APPROVALS		DATE	 Wulfsberg Electronics <i>A Chelton Group Company</i>			
DRAWN	T. Mallette	2/26/04	TITLE: SERVICE BULLETIN WSB VC-401C-05 REMOVE CAPACITOR TO ELIMINATE A RARE FAILURE MODE			
CHECKED	C. Estes	2/26/04				
PRODUCT MANAGER	R. Evans	2/26/04				
ENGINEER	V. Wallace	2/26/04				
ISSUED	R. Talken	2/26/04				
Typed signatures indicate approval. Handwritten signature approval of this document is on file at Wulfsberg Electronics, Prescott, Arizona.			SIZE 	CAGE CODE 1B7G3	DWG NO. 150-042824	REV A
			SCALE: NONE		DO NOT SCALE DRAWING

SERVICE BULLETIN

BULLETIN NUMBER: WSB VC-401C-05 Revision A

This service bulletin will remove C3 from the Power Amplifier board to eliminate a rare failure mode.

Figure 1

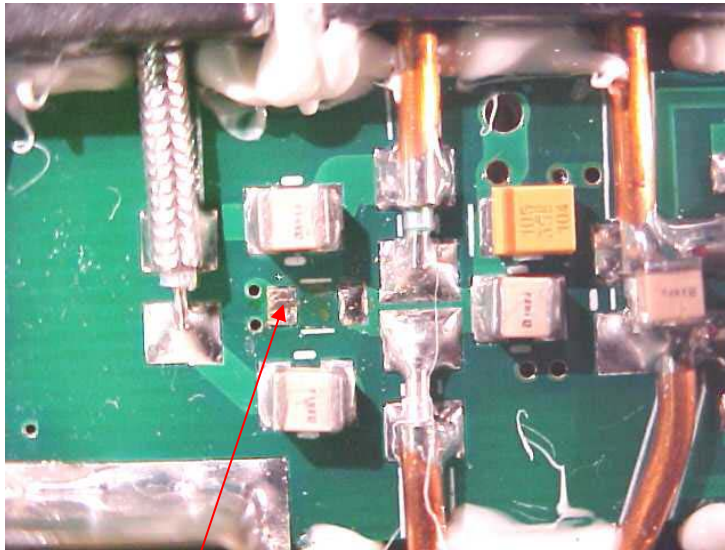
Remove capacitor C3 (106-04224-0047) from the intersection of T4, T5, and T6. Leave the circuit pads open. Do not replace the component. See Figure 1.

C3 removed
Do not replace.
